# Metropolitan Commission of Sewers.

### DRAINAGE OF THE NEW PALACE AT WESTMINSTER.

*Mr Austin's Report.*

*Mr Barry's Reply.*

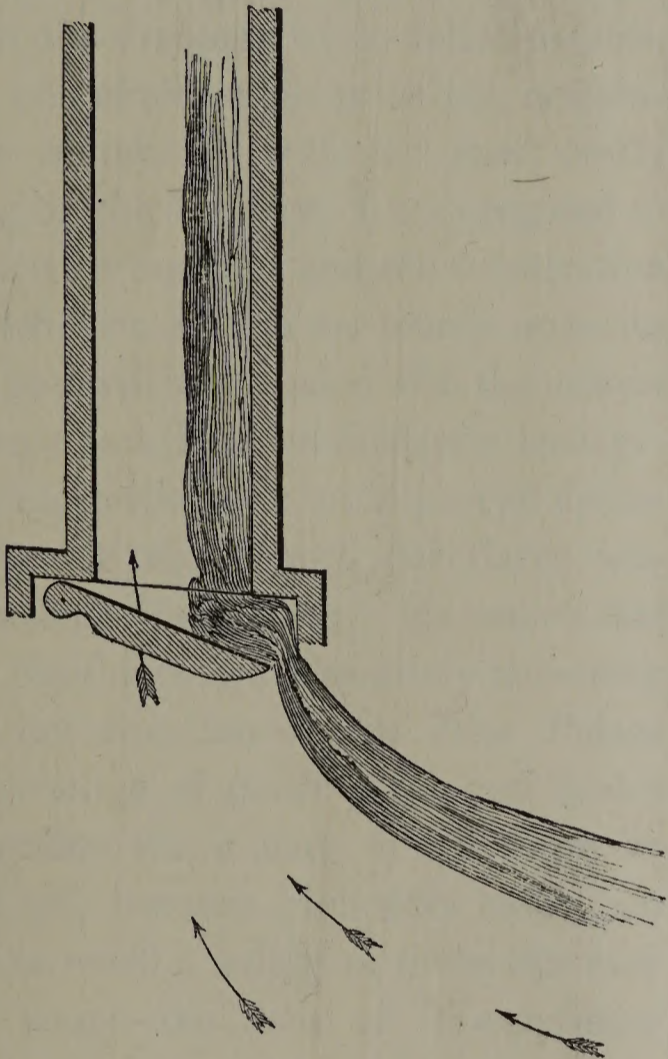
It is a fallacy to suppose that flaps, placed at the mouths of the drains, communicating with the sewer, will at all times prevent the escape of this dangerous miasma. Even supposing that the contact of the surfaces could at all times be perfectly preserved, every time that a discharge takes place, and the flap is raised, an opening is formed through which the foul and pent-up gases will rise and escape into the building as indicated in this section.

That the flaps to the branch drains are not fixed for the purpose of preventing the escape of foul air into the building, as Mr Austin seems to suppose, although they may contribute to that object; but that other and perfectly effective means are provided for that purpose, of which he appears to be ignorant. All Mr Austin's reasoning, therefore, upon these flaps and their admission of foul air into the building falls to the ground.
